ADDENDUM #1

Reference: Fire Alarm Upgrade – Washburn Building
Snow College South - Richfield, Utah
DFCM Project No. 07159700

SUBJECT: DFCM # 07159700 – Snow College Richfield Washburn Building
Description of Drawings Revisions for Addendum #1

FIRE ALARM INITIATING DEVICE PLAN - NORTHEAST
FA-2

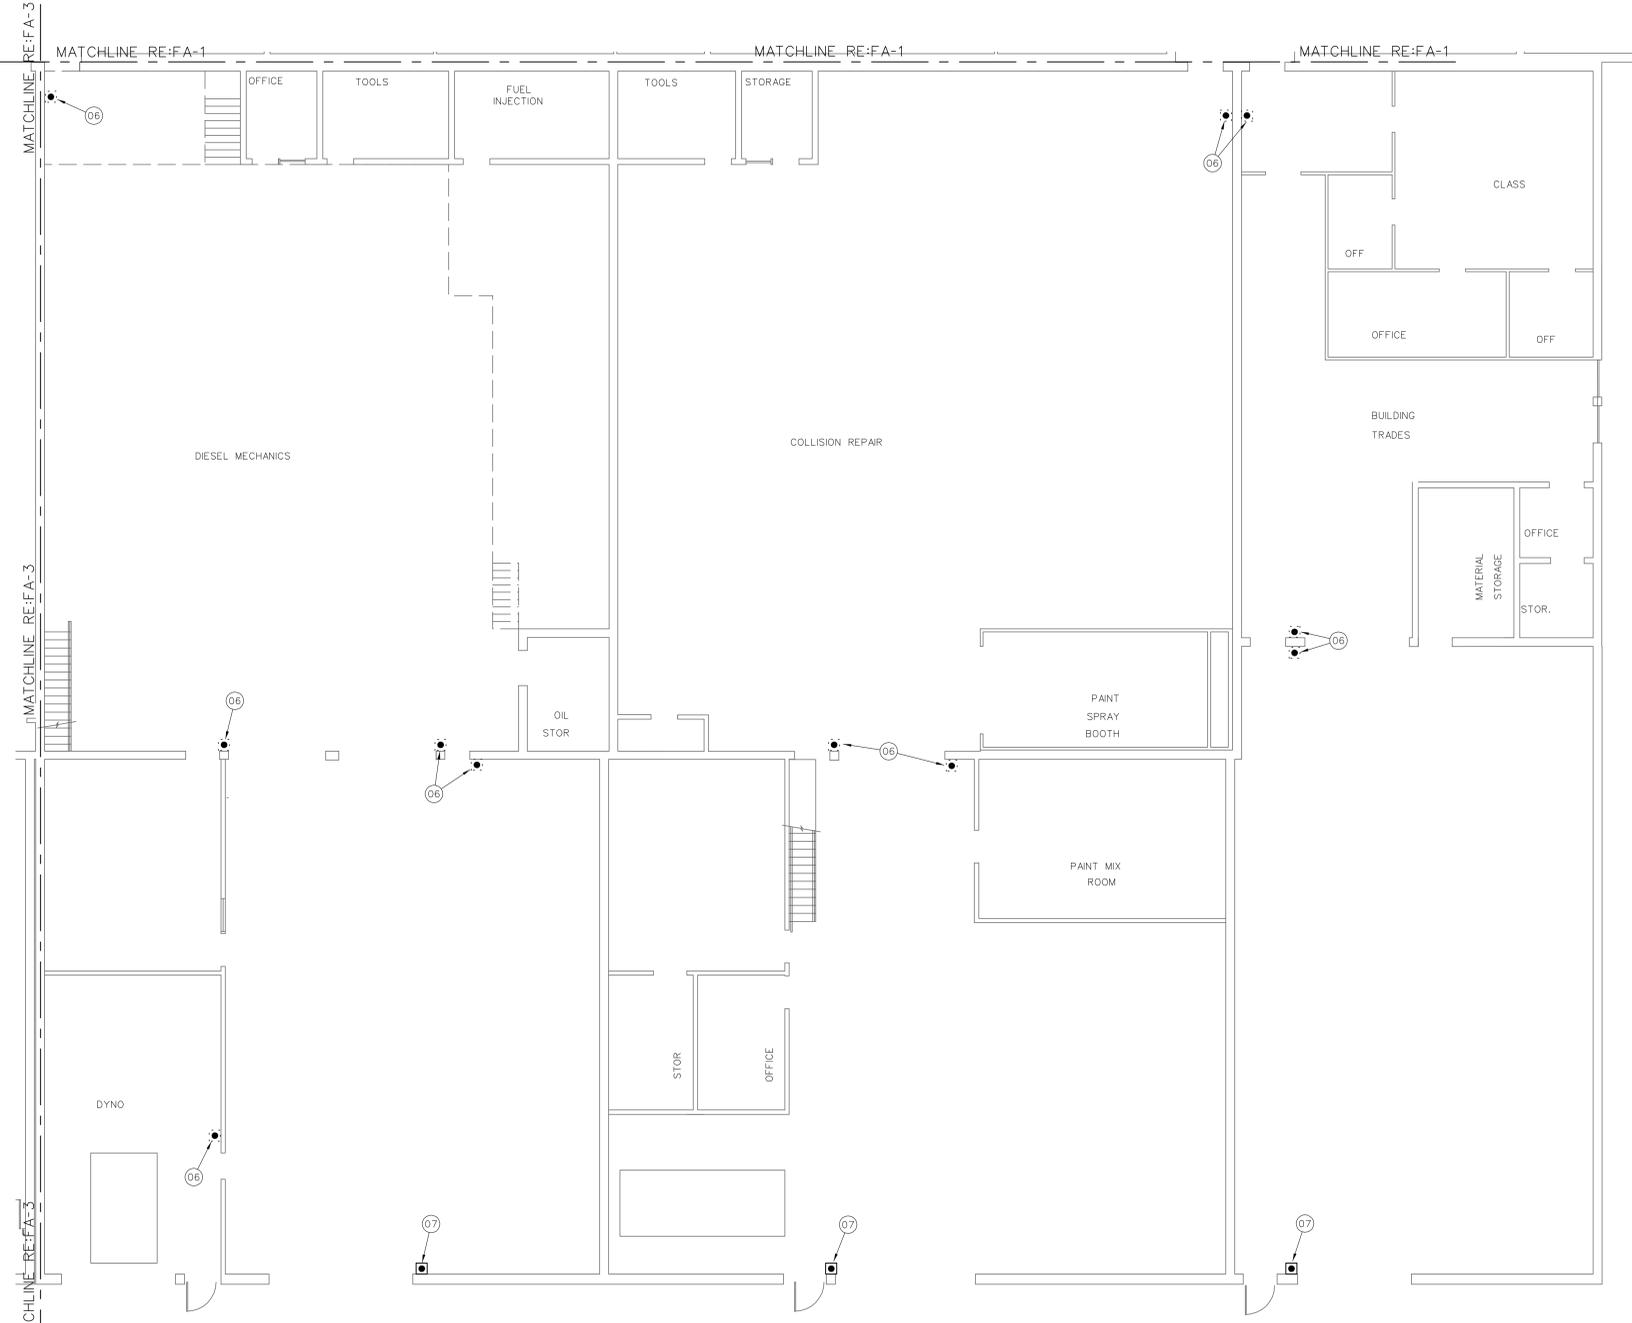
Sheet FA-2:

6. Sheet issued in its entirety. This sheet was not included in the bid set.

FIRE ALARM INITIATING DEVICE PLAN - SOUTHWEST
FA-4

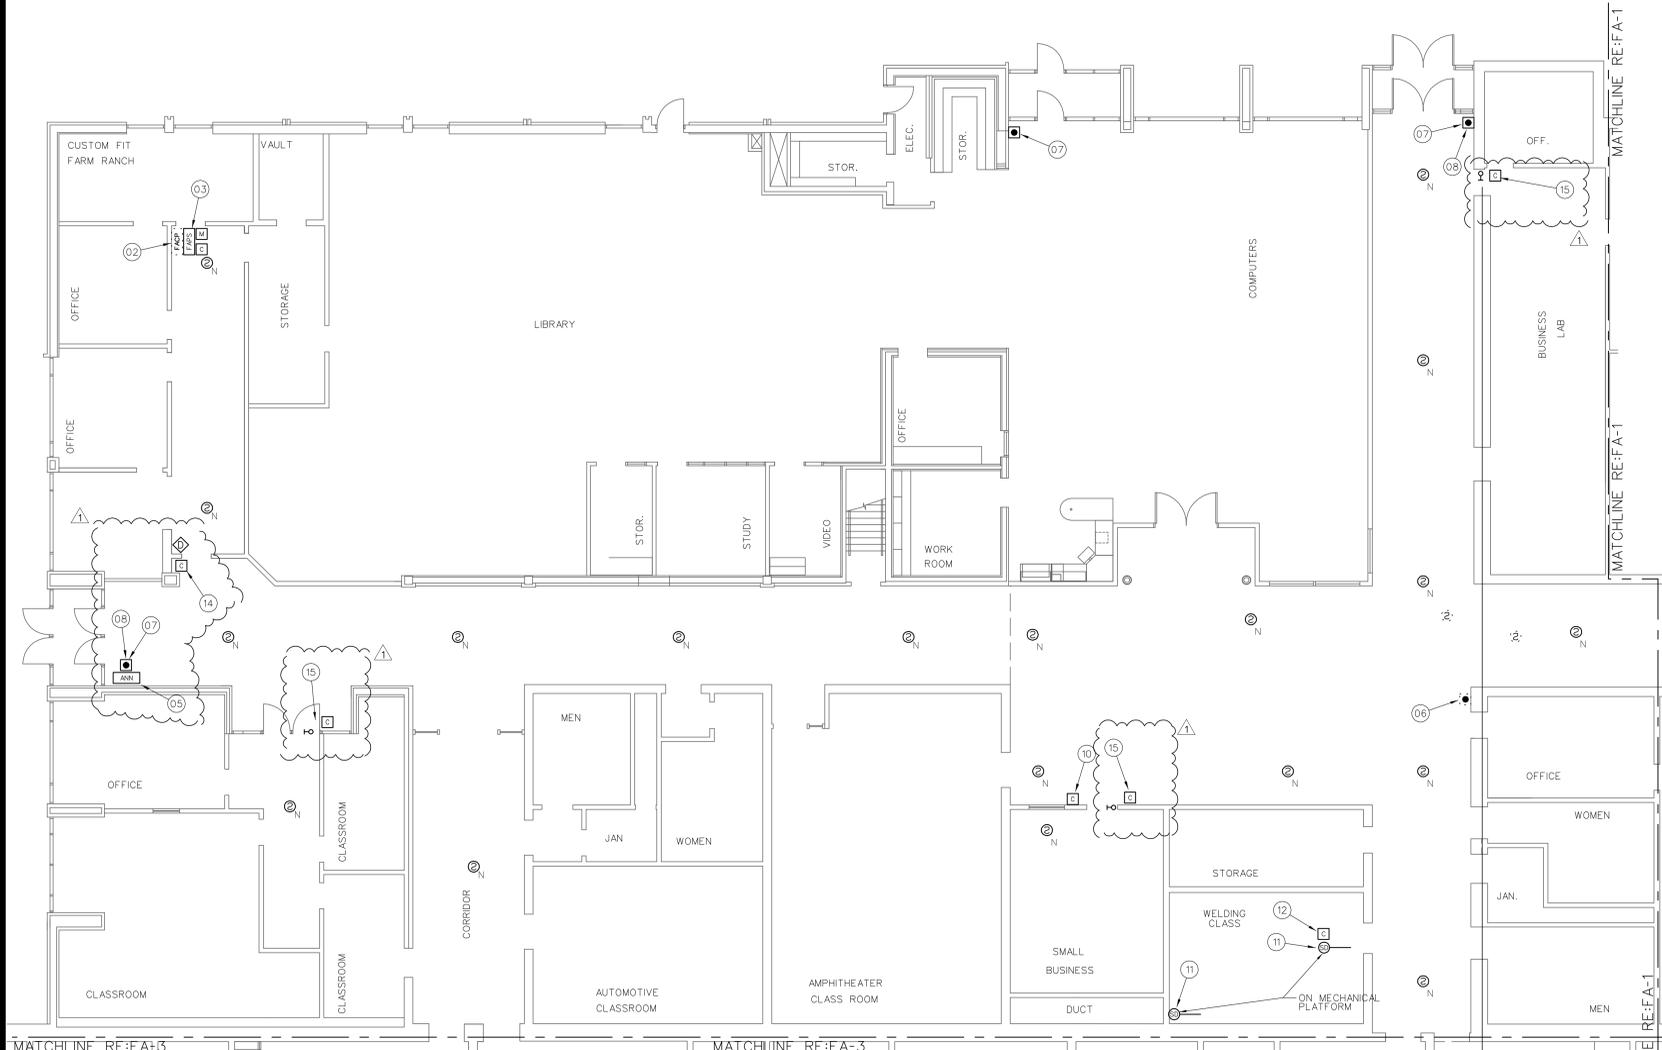
Sheet FA-4:

7. Annunciator panel at south entry was relocated to the opposite side of the corridor due to the recent installation of a bulletin board that conflicts with the location shown on the bid drawings.
8. Wall mount magnetic type door hold open device with fire alarm control relay for actuation was added to door between southeast offices and Corridor (drawing coordinate H2).
9. Door closures with integral hold open devices, along with fire alarm control relays for actuation were added to the following doors:
 - a. Door between USU extension offices and Corridor (coordinate I2)
 - b. Door between Small Business and Corridor (coordinate I7)
 - c. Door between Business Lab and Corridor (coordinate F9)

FIRE ALARM NOTIFICATION APPLIANCE PLAN SOUTHEAST
FA-7

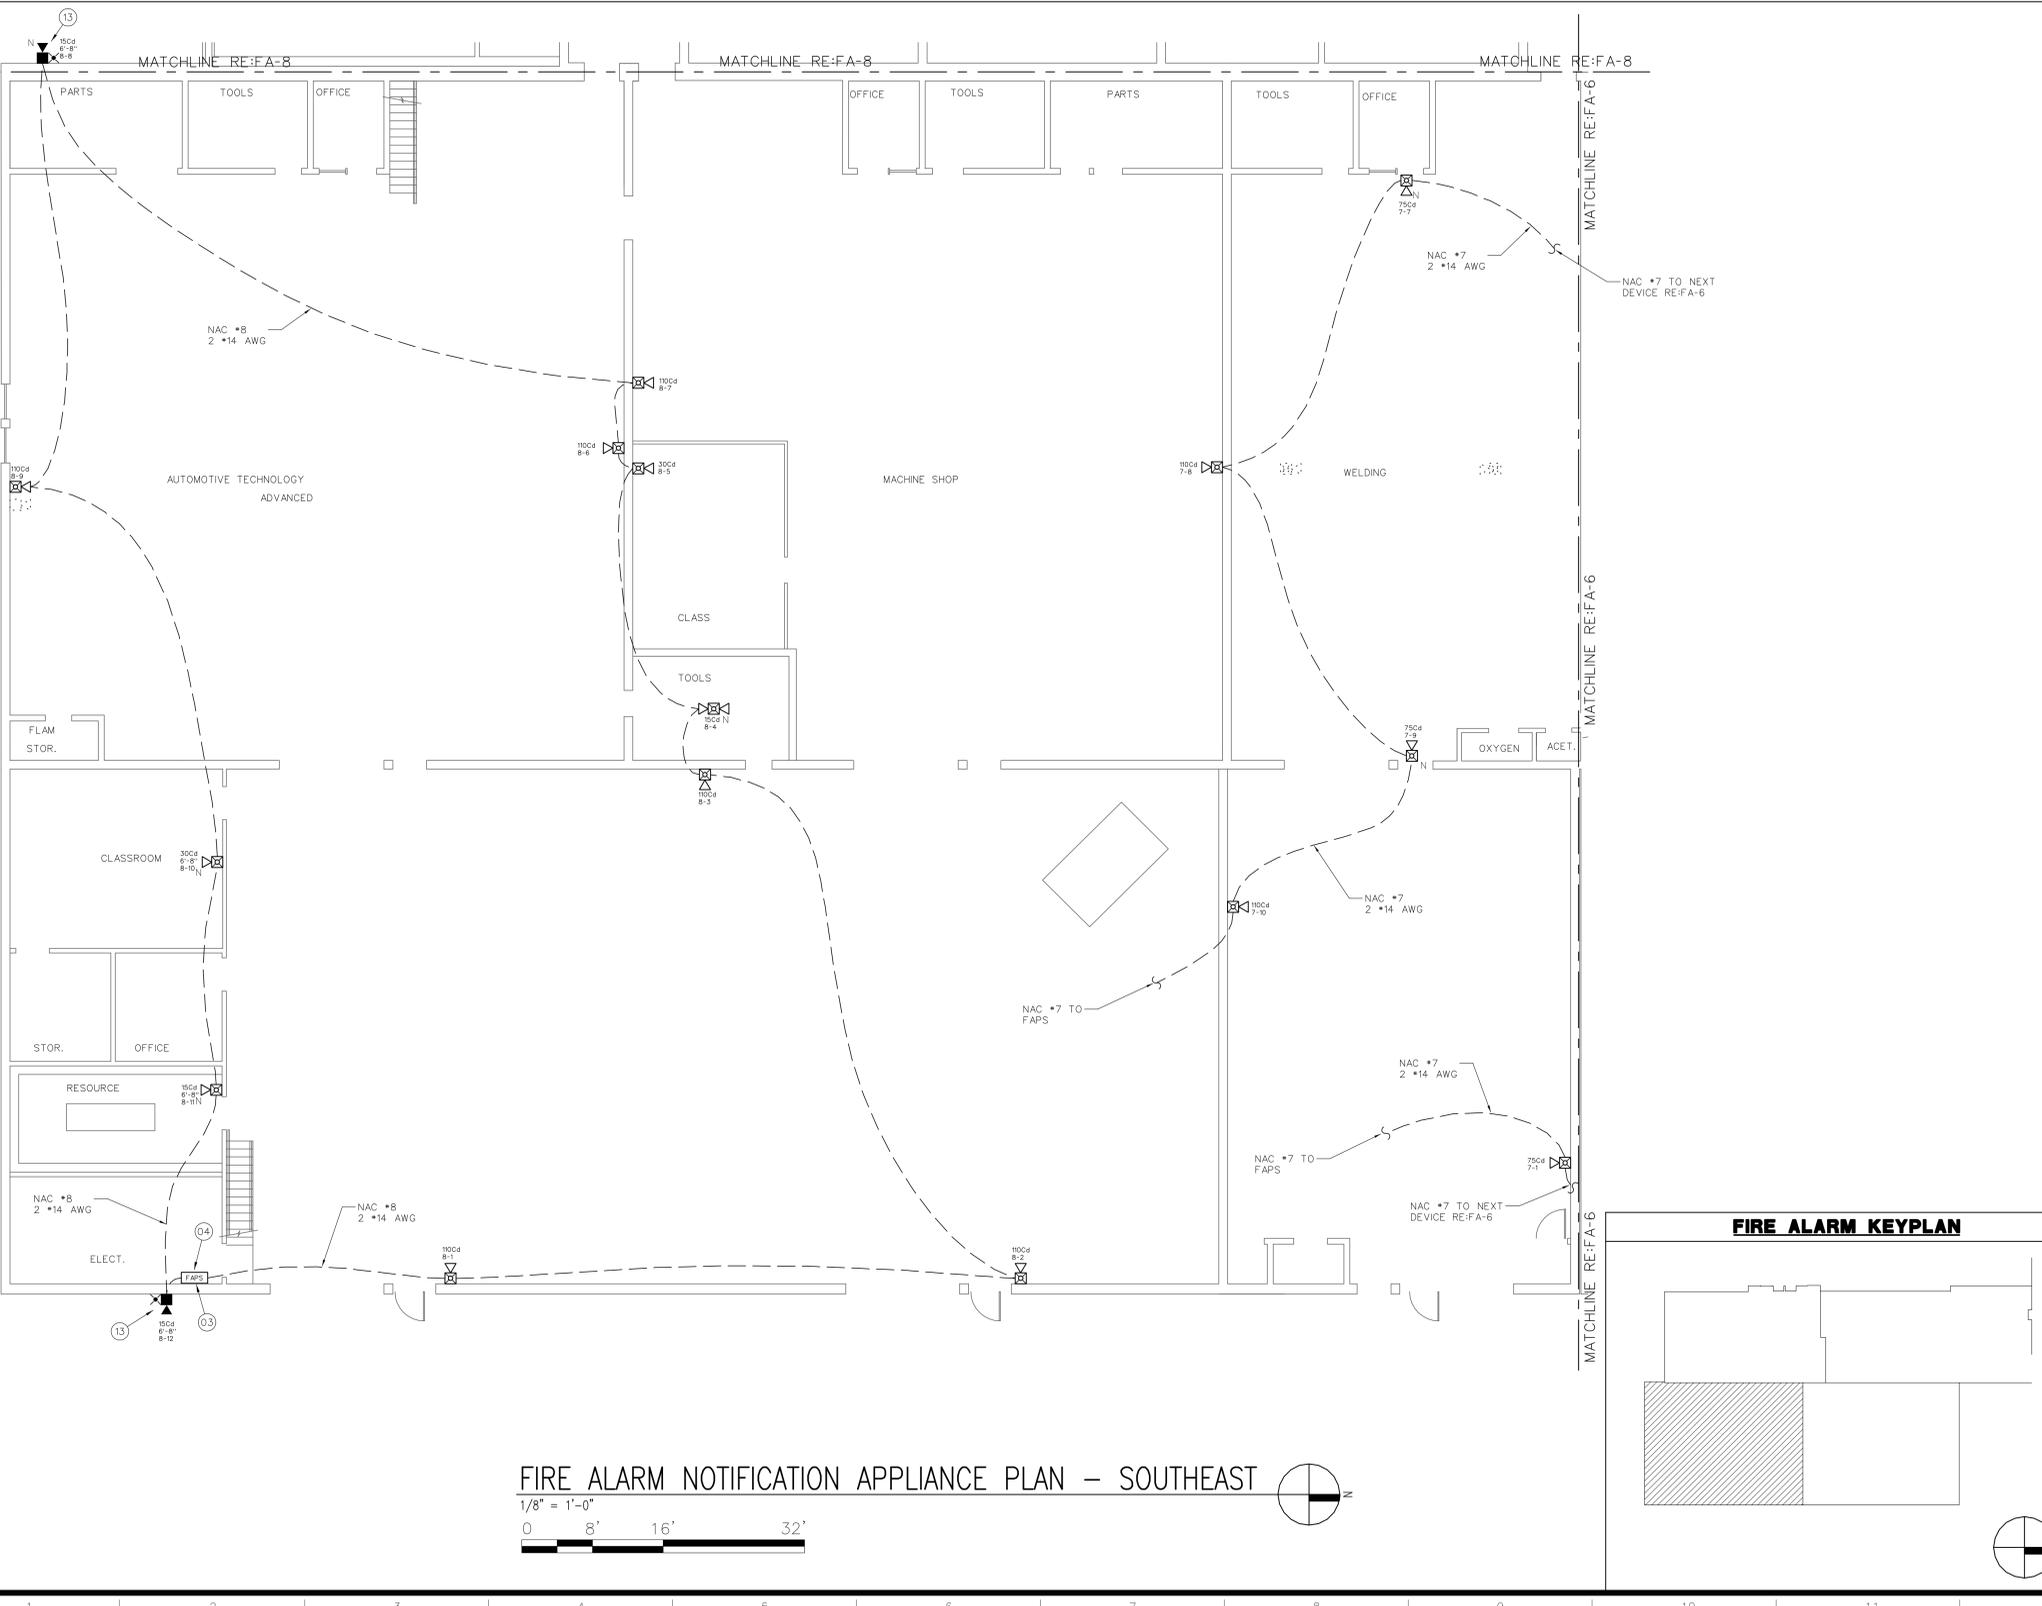
Sheet FA-7:

10. Sheet issued in its entirety. This sheet was not included in the bid set.

1 FIRE ALARM SINGLE LINE RISER DIAGRAM

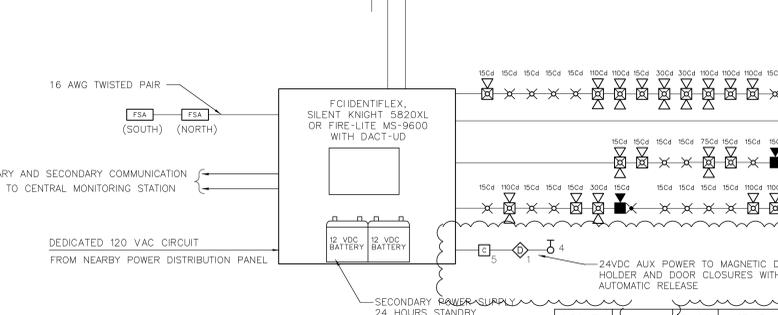
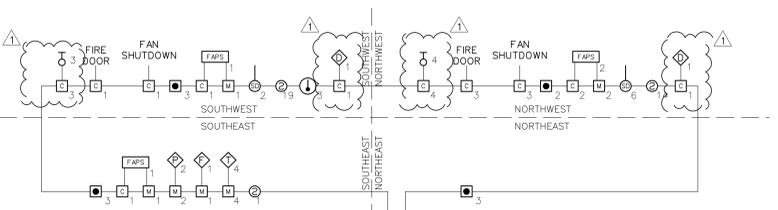
Sheet FA-9:

11. Updated fire alarm riser (detail 1) to include additional control relays for door release. Nine control relays added.
12. Updated fire alarm riser (detail 1) to include 24 VDC aux power output for door hold open devices.
13. Updated detail for remote power supply #4 (detail 5) to include 24 VDC aux power output for door hold open devices.
14. Updated sequence of operation to include fire sprinkler devices (inputs) and door release (outputs).
